Suncor Energy Inc.

Application for an External Tailings Pond
for the Millennium Mine
Fort McMurray Area

Decision 2004-113: Suncor Energy Inc., Application for an External Tailings Pond for the Millennium Mine, Fort McMurray Area

Decision 2004-113
Application No. 1325847

Figure 2. South tailings pond detail

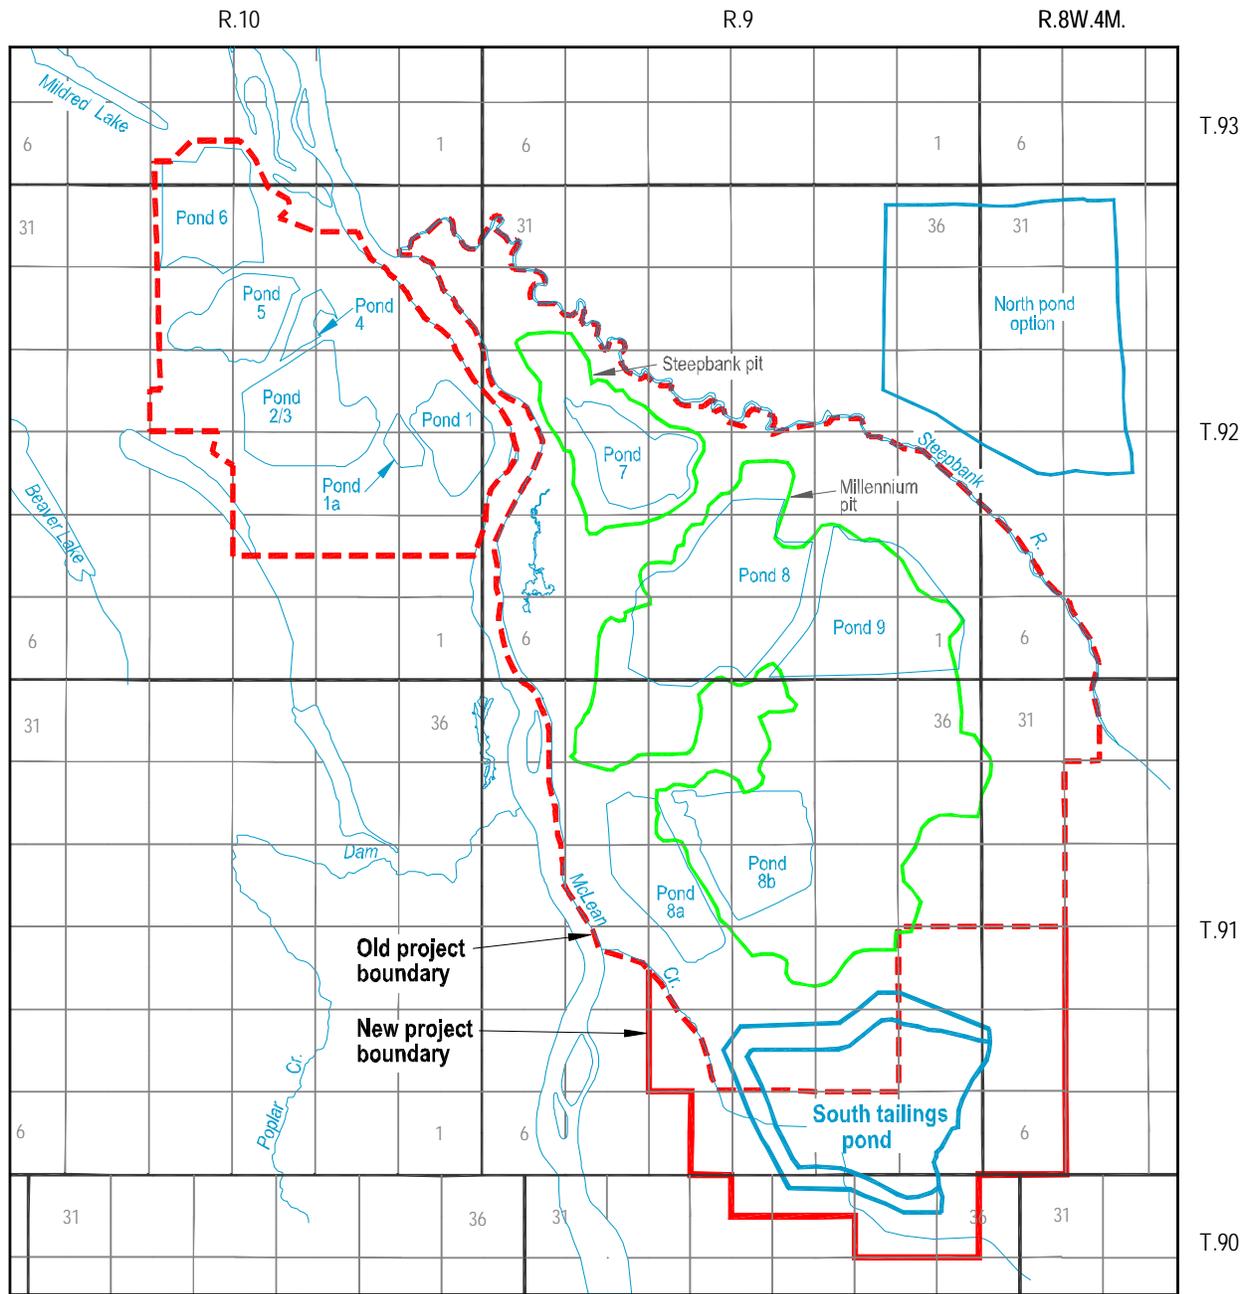
Suncor indicated that a hydrogeological assessment of the STP area identified several potential pathways for foundation seepage to escape the pond area, including through the underlying WCSC, the underlying sand layers in the till, particularly on the north section of the dike, and the kame deposit (see Figure 2) that intersects the final pond elevation and the final south dike abutment.

The Board notes that glacial landforms, such as kame deposits, are complex stratigraphically and will possess complex hydrogeological regimes not easily explained with only limited geological and hydrogeological information. The Board is concerned that, depending on the nature of this glacial landform, other seepage pathways could exist that might circumvent the planned seepage control structures.

Figure 1. Suncor oil sands mine project map

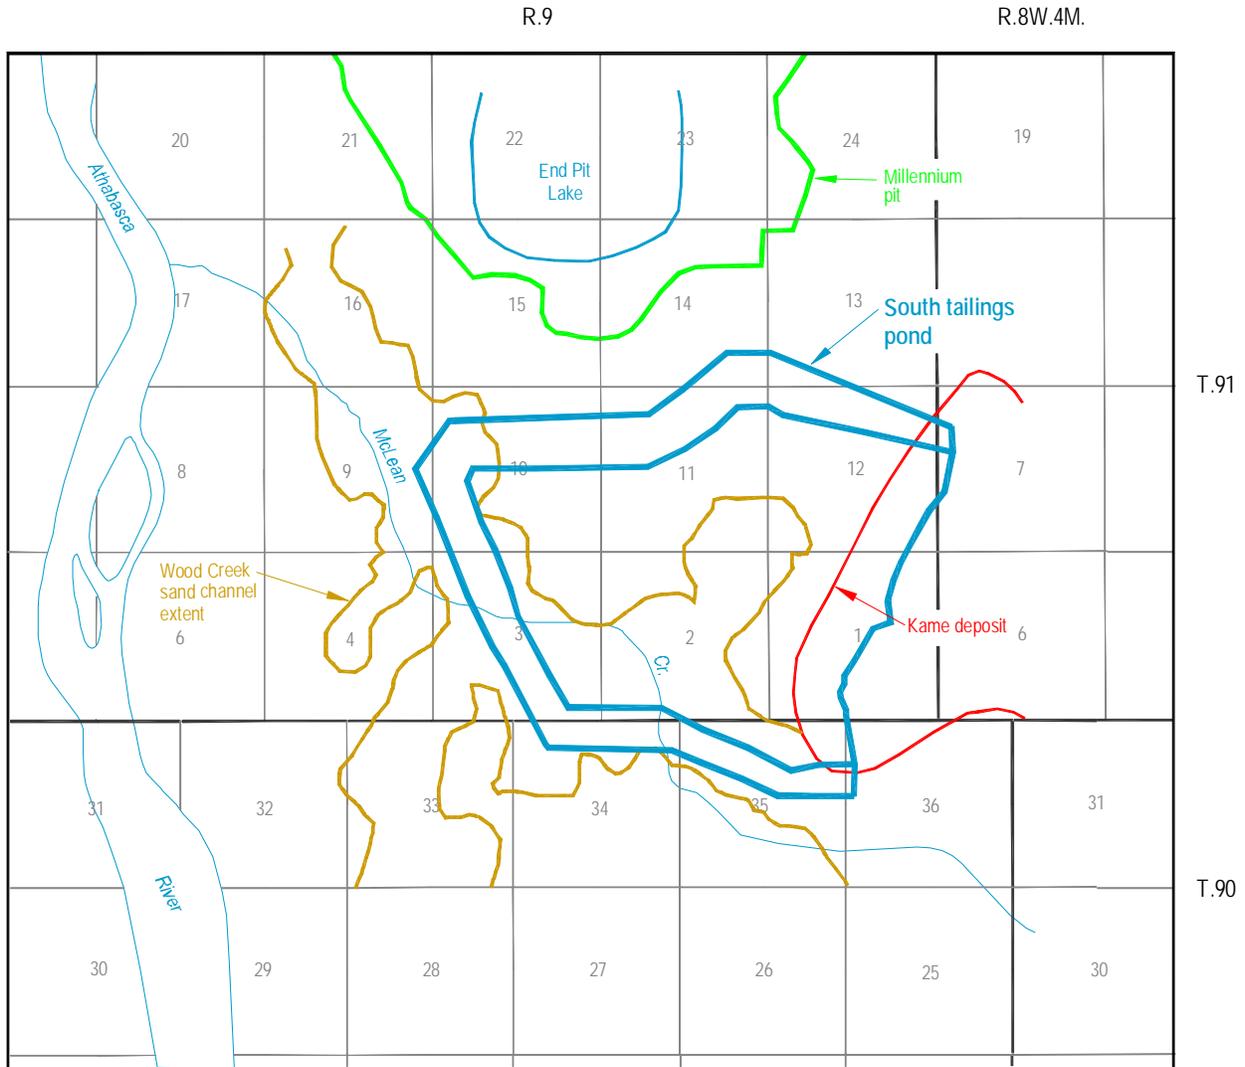
Suncor stated that it had completed a screening study on three potential out-of-pit tailings disposal areas (see Figure 1):

Suncor indicated that it had ruled out the East Option at the outset due to its remoteness, topography, and ground conditions. Suncor also noted that this location would not permit a pond of the required capacity.

In comparing the North and South Options, Suncor indicated that it had selected the South Option (the STP) because it presented the following advantages:

The Board acknowledges that determination of the suitability of a tailings pond location requires careful consideration of trade-offs between evaluation criteria. Furthermore, the Board agrees with Suncor's assessment that the South Option is preferred to the North Option for reasons of cost, location, and operability. The Board is also satisfied that the East Option did not require a detailed evaluation, given its location and because it would not have provided the required capacity.
